Well Name: CANYON LARGO UNIT	Well Location: T25N / R7W / SEC 13 / SESE / 36.394928 / -107.520386	County or Parish/State: RIO ARRIBA / NM
Well Number: 52	Type of Well: CONVENTIONAL GAS WELL	Allottee or Tribe Name:
Lease Number: NMSF078880	Unit or CA Name: CANYON LARGO UNIT--PC	Unit or CA Number: NMNM78383A
US Well Number: 3003905970	Operator: HILCORP ENERGY COMPANY

Notice of Intent

HILCORP ENERGY COMPANY
CANYON LARGO UNIT 52
P&A NOI

Notice of Intent – Plug and Abandonment

P&A WBD Proposed

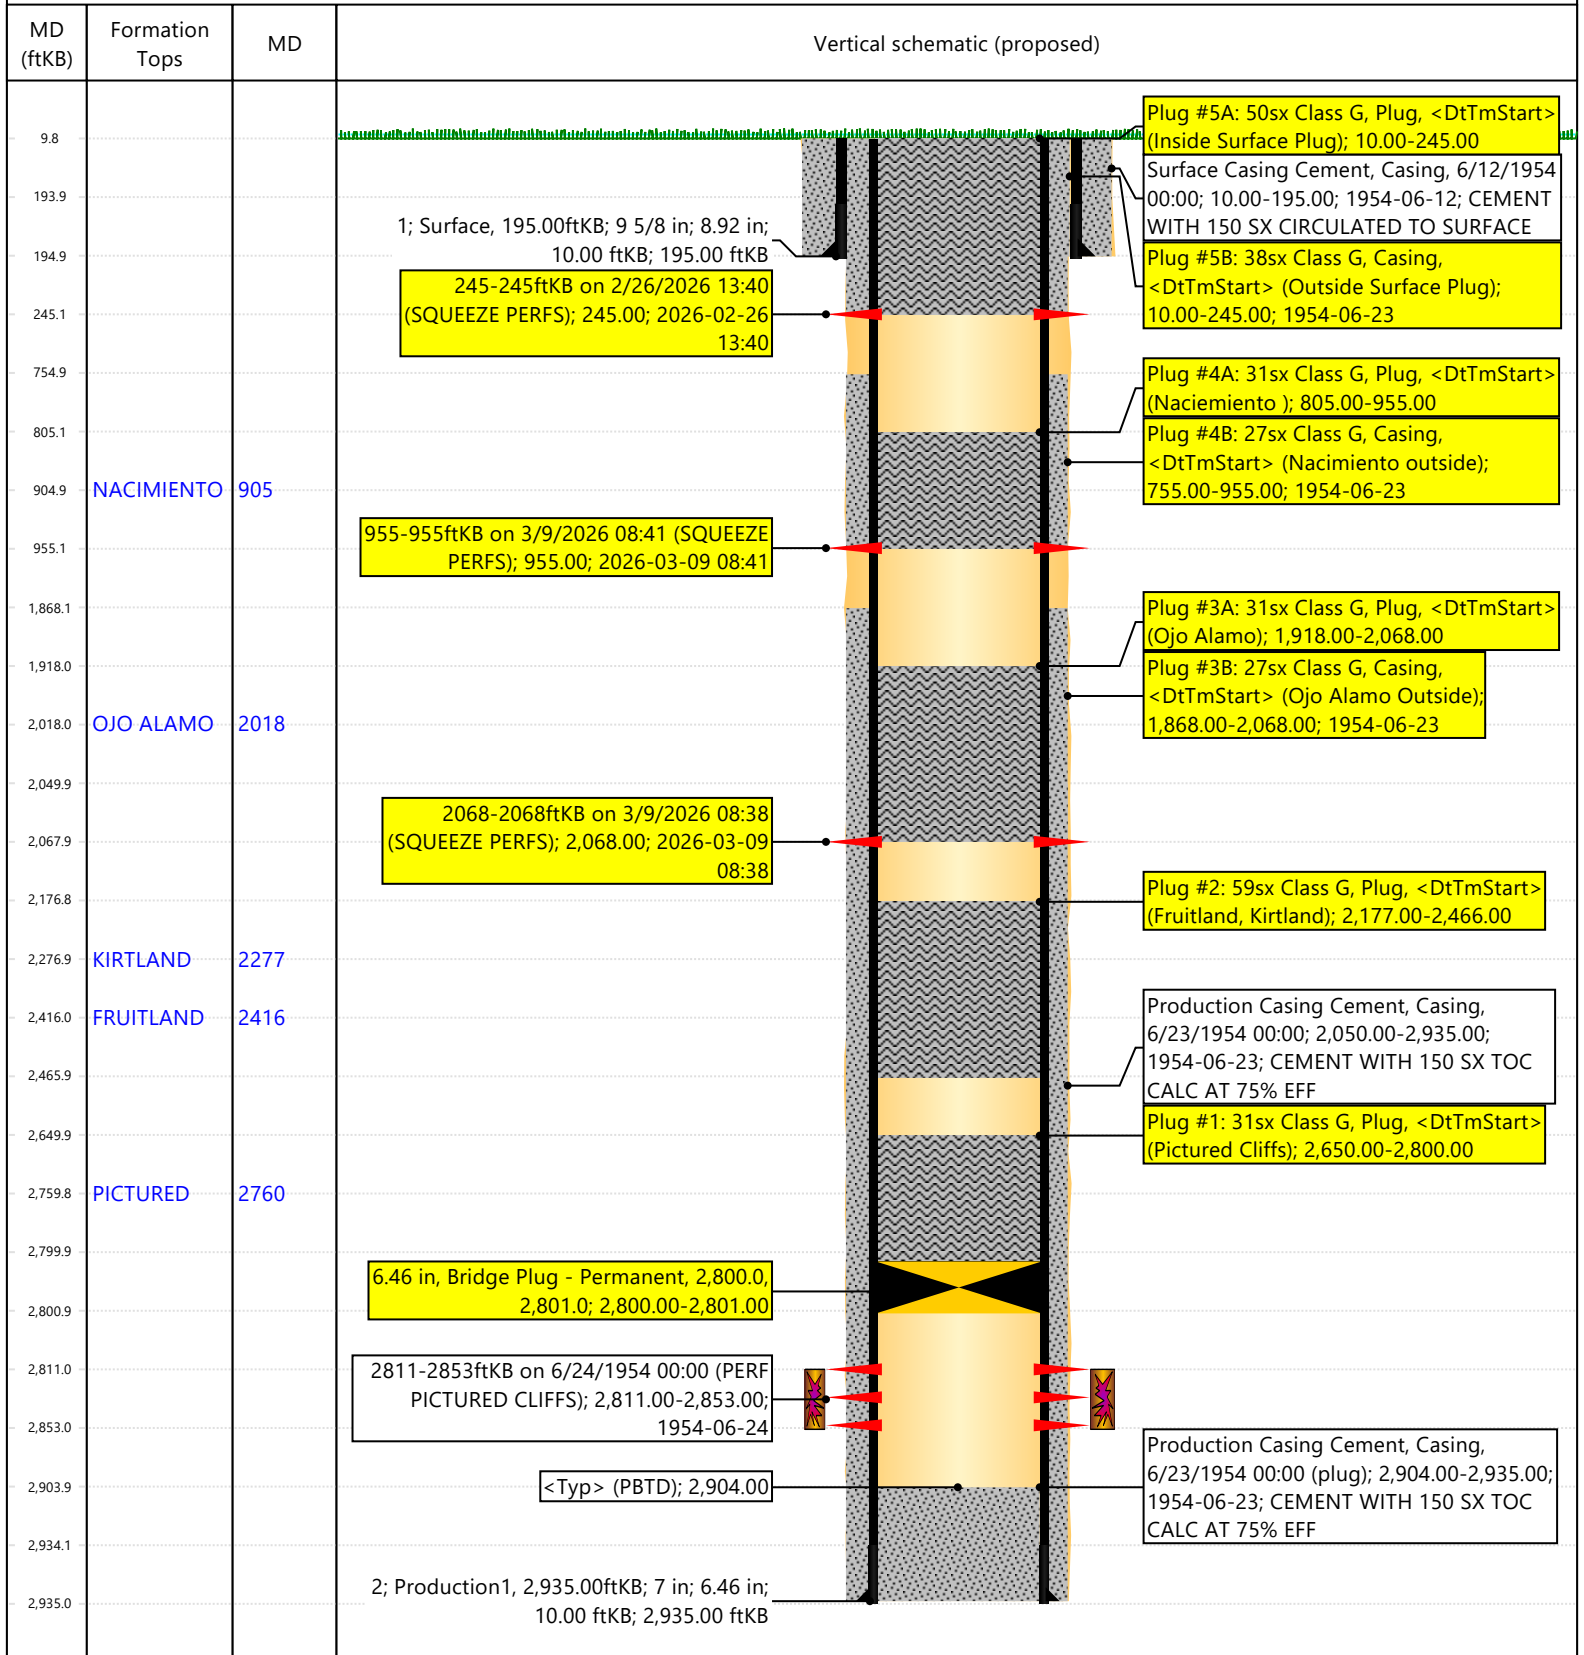
Remarks: Please adjust all plugs to cover BLM-Picked formation tops.

1. Plugging operations authorized are subject to the attached "General Requirements for Permanent Abandonment of Wells on Federal and Indian Lease."
2. The following modifications to your plugging program are to be made:
 - a. Adjust Plug 2 and Plug 3 to account for BLM geologist's formation picks for the Ojo Alamo at 2082' and the Kirtland at 2160'. Recommendation is to modify Plug 2 TOC to the perforations as proposed for Plug 3.
3. **Notification:** Farmington Office is to be notified at least 24 hours before the plugging operations commence at (505) 564 7750.

You are also required to place cement excesses per 4.2 and 4.4 of the attached General Requirements.
